AGENDA
Regular Hybrid Meeting
Town of Granby
Planning & Zoning Commission
Tuesday, June 24, 2025, at 7:00 pm
Town Hall Meeting Room

RE: Application seeking a Site Plan and Special Permit under Zoning Regulations Sections 3.5.4.3, 8.6.14 and 8.21.4 for a commercial building in the Aquifer Protection Overlay Zone with an illuminated freestanding directory sign and outdoor storage, for property located at 14 Mill Pond Drive, C2 Zone: File Z-7-25.

Plan: "Proposed Commercial Facility, #14 Mill Pond Drive, Granby, Connecticut 06035, May 2, 2025, Biff Schechinger, Landscape Architect, Revised 4 June 2025, marked up copy revised 6/18/2025."

PROPOSED COMMERCIAL FACILITY
#14 MILL POND DRIVE; GRANBY, CONNECTICUT 06035

Drawing Title:
Proposed Commercial Facility:
#14 MILL POND DRIVE, GRANBY, CT
**GRADING &
DRAINAGE PLAN**

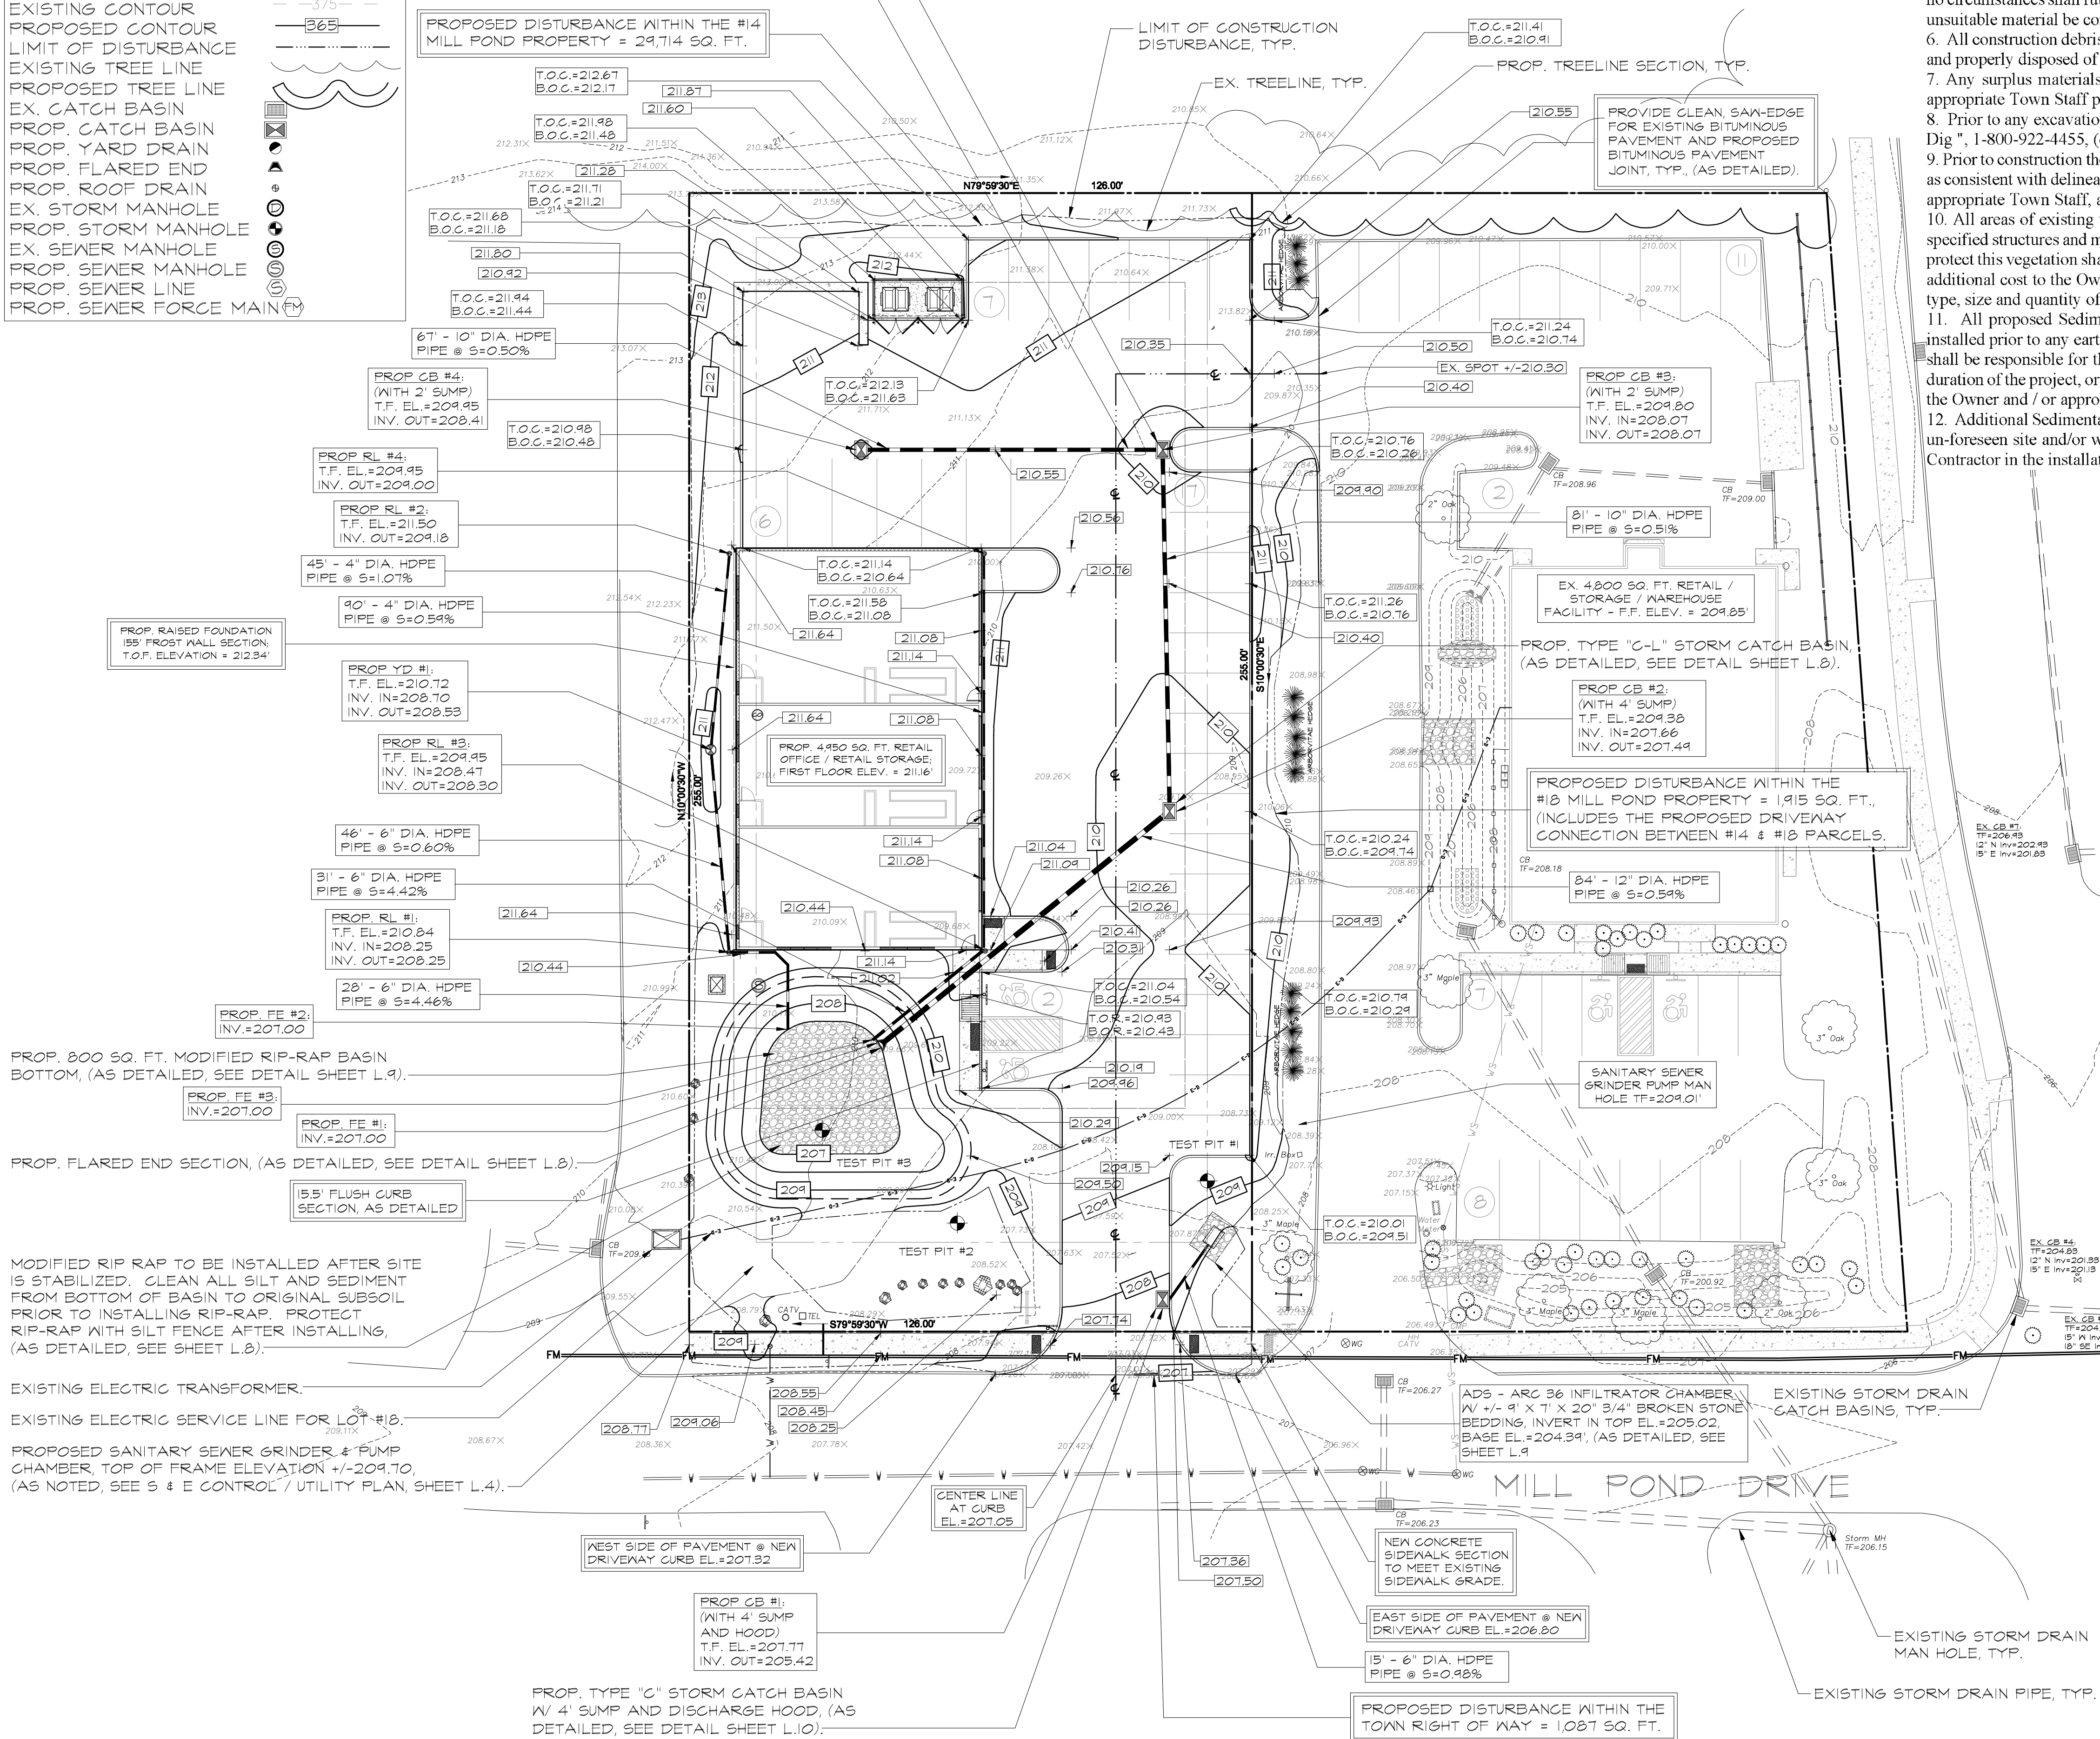
- ✓ 23. Sanitary sewer has been re-routed as requested. Suggest moving proposed pump station close to the building with a force main to the street.
- ✓ 26. Regarding the Water Quality Basin Preparation Notes, compacted fill is not to be placed in the infiltration portion of the basin. In the "Water Quality Basin Preparation Note," remove reference to placing compacted fill in the basin.
- ✓ 28. A project narrative is required for erosion and sediment control plans. See chapter 3 page 44 of Connecticut Guidelines for the information required. For this project include items i through vii. Refer to the latest manual effective March 30, 2024.

30. Reference the current Connecticut Guidelines for Soil Erosion and Sediment Control.

sheet L.3 - E&S Control note #1

EAVE SIDE 1 ELEVATION

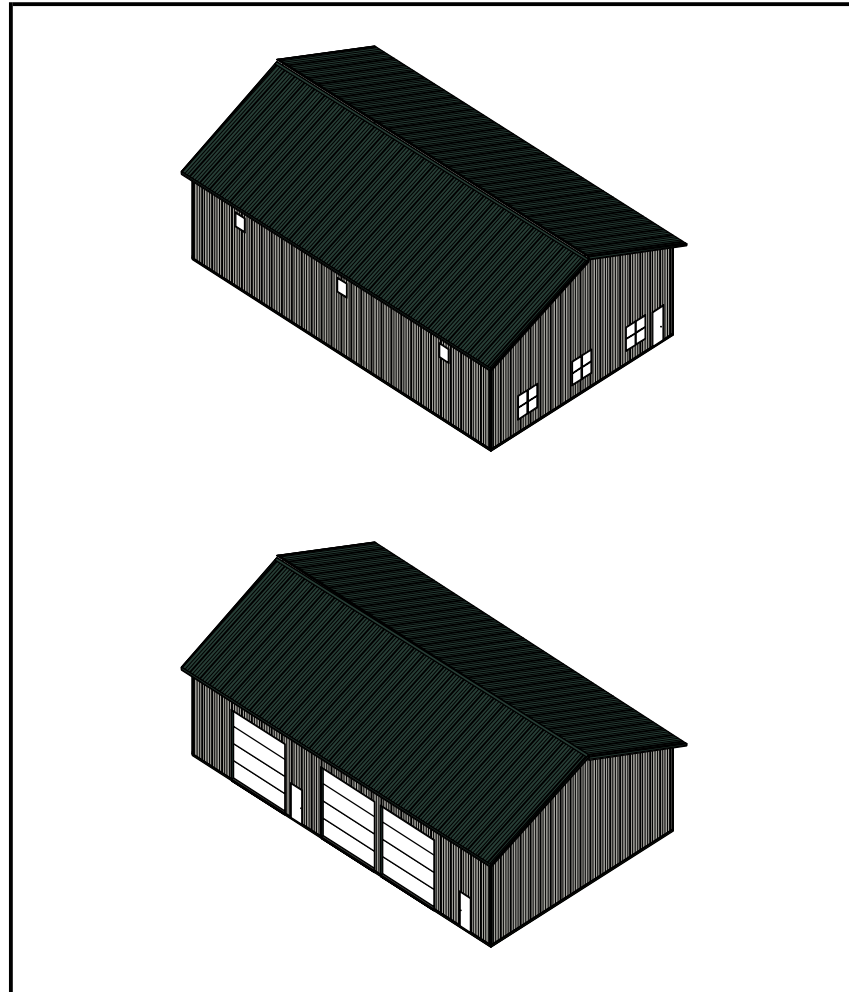
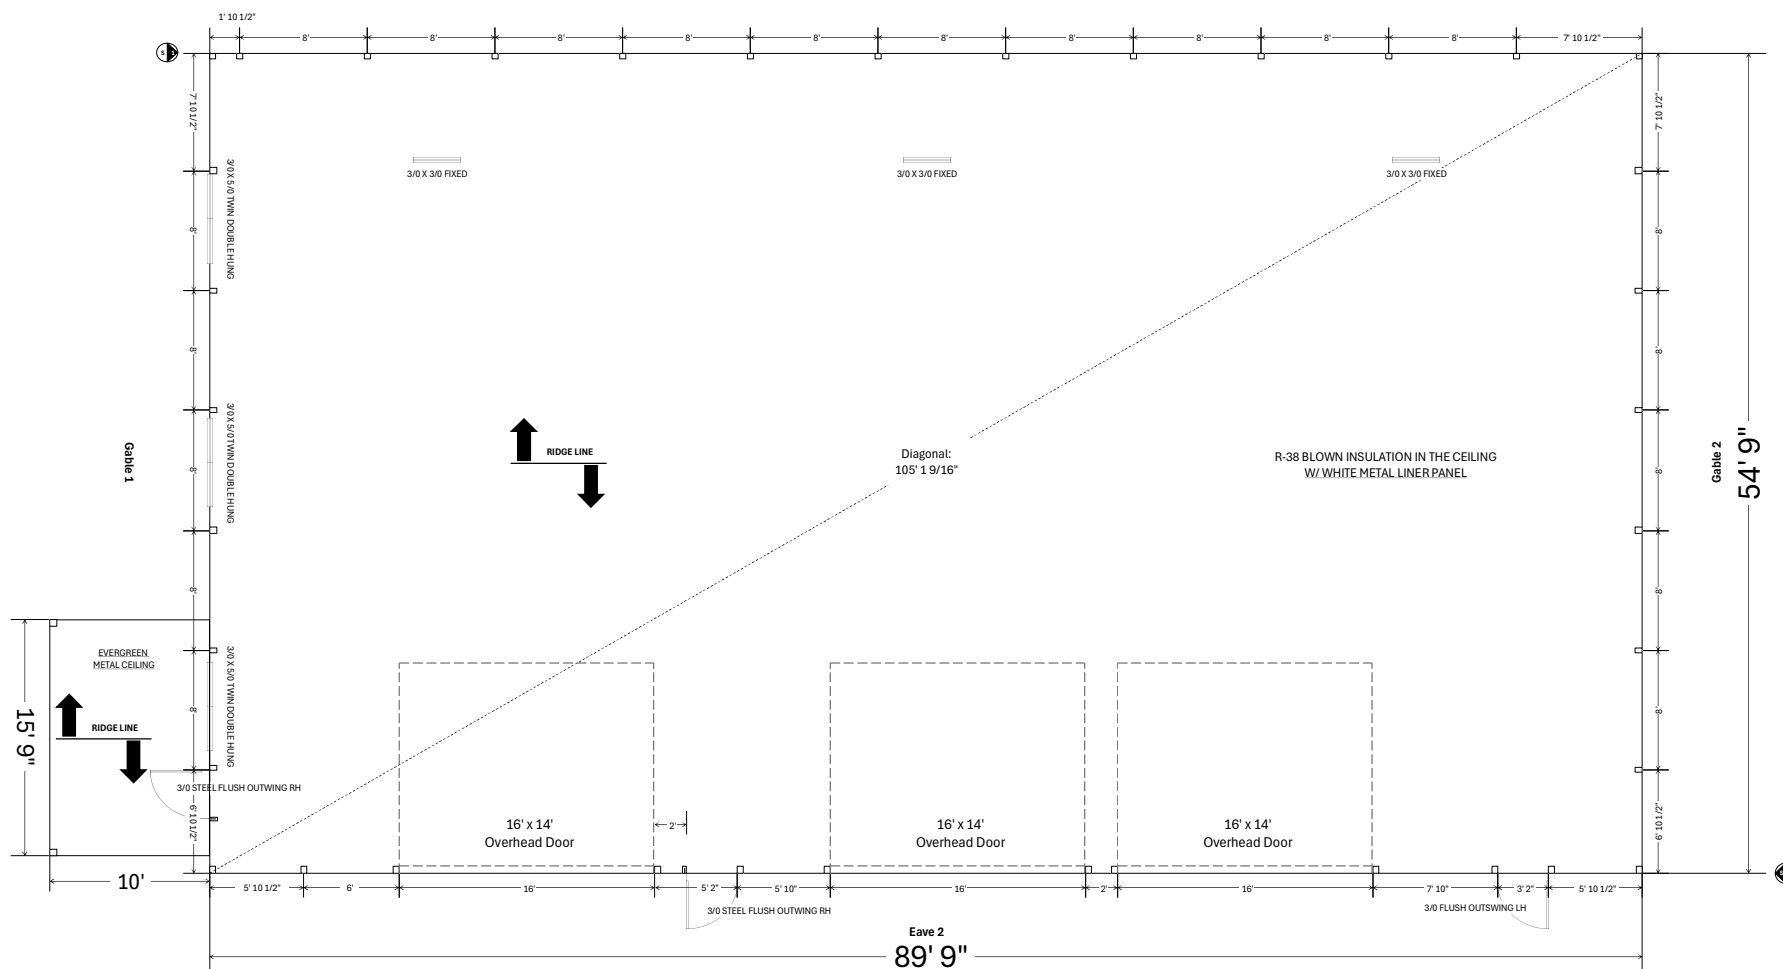
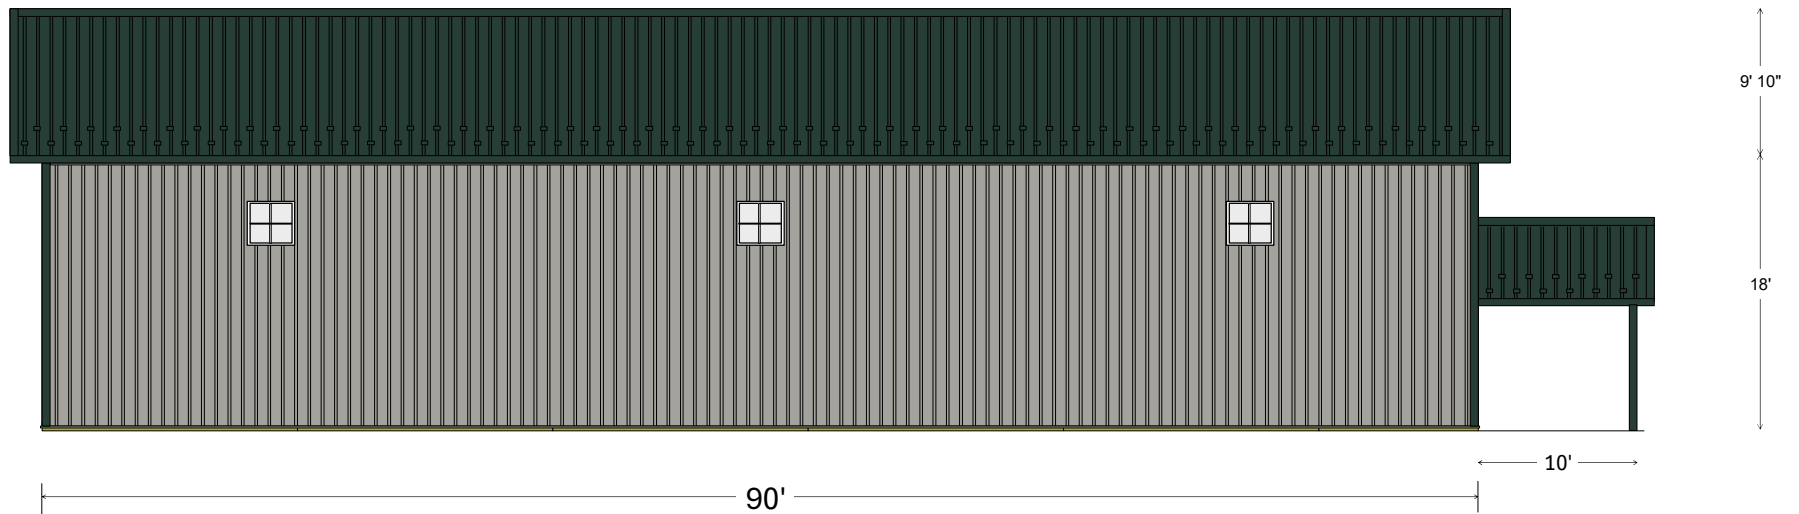
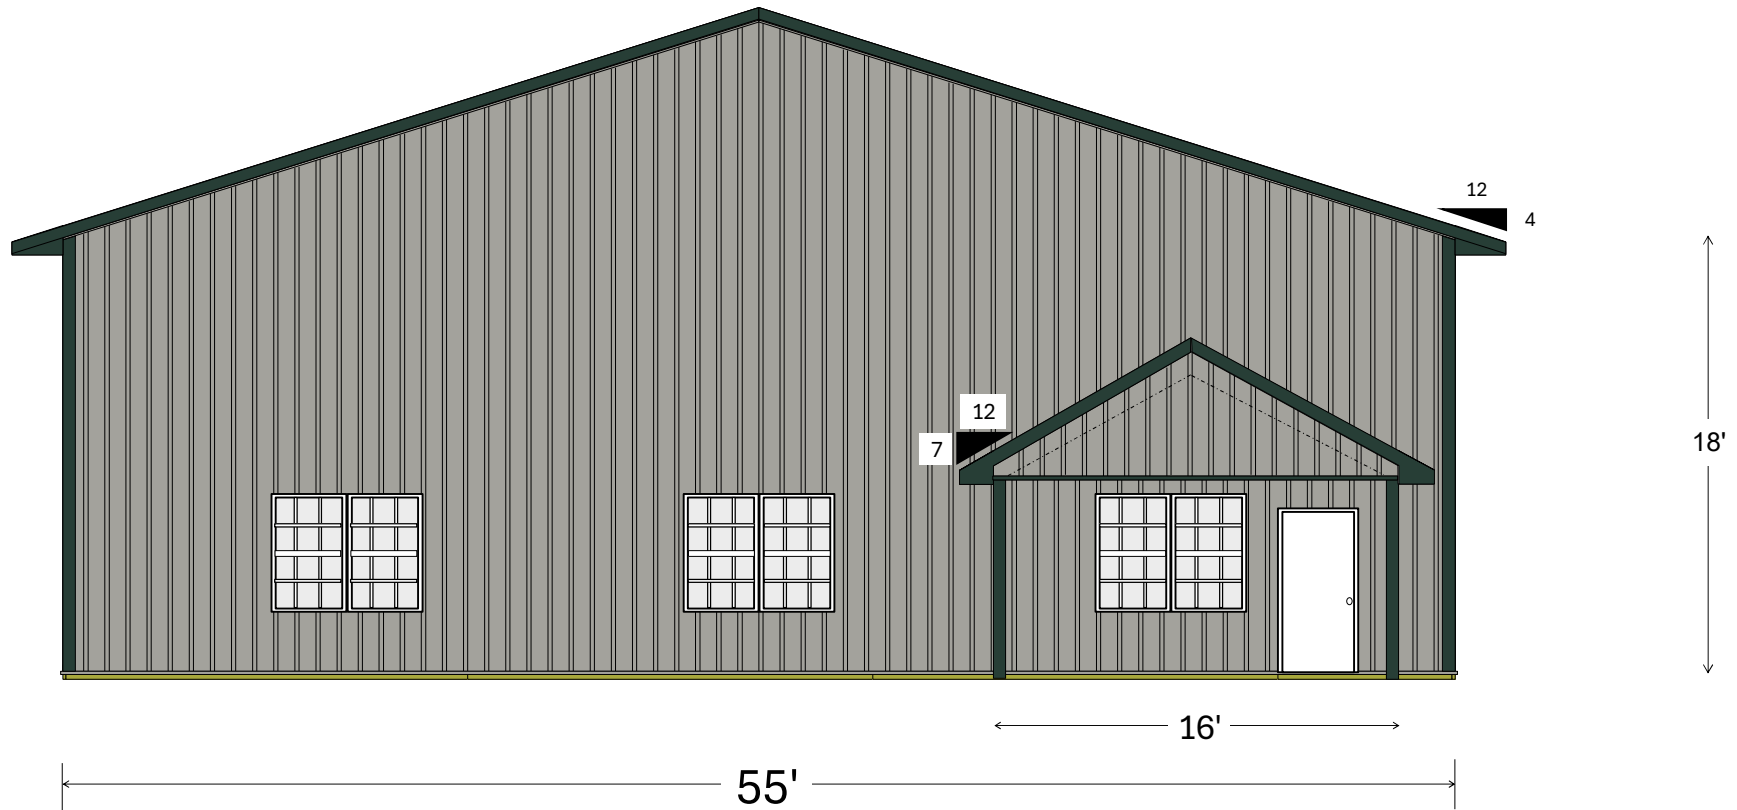
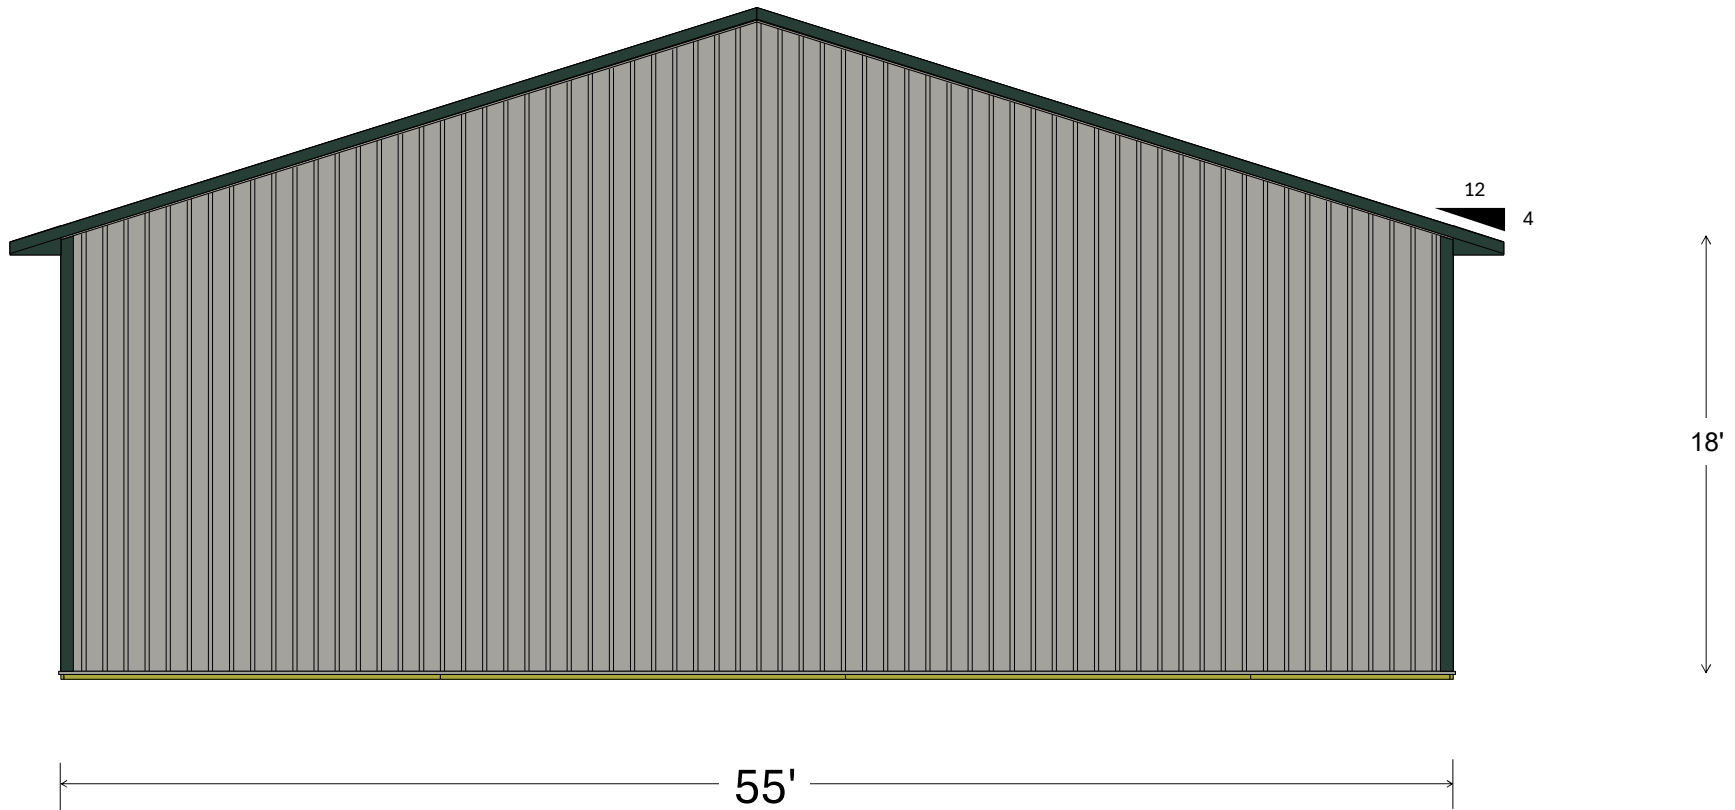
- 1) Provide the updated building elevation showing the pedestrian door and location of the sidewalk. It is understood that the pedestrian door will face Mill Pond Drive.
- 2) Consider adding an awning or roof over the pedestrian door or some other feature on the south building elevation visible from Mill Pond Drive. Another window closer to the peak was mentioned as well. Below are pictures of nearby buildings.
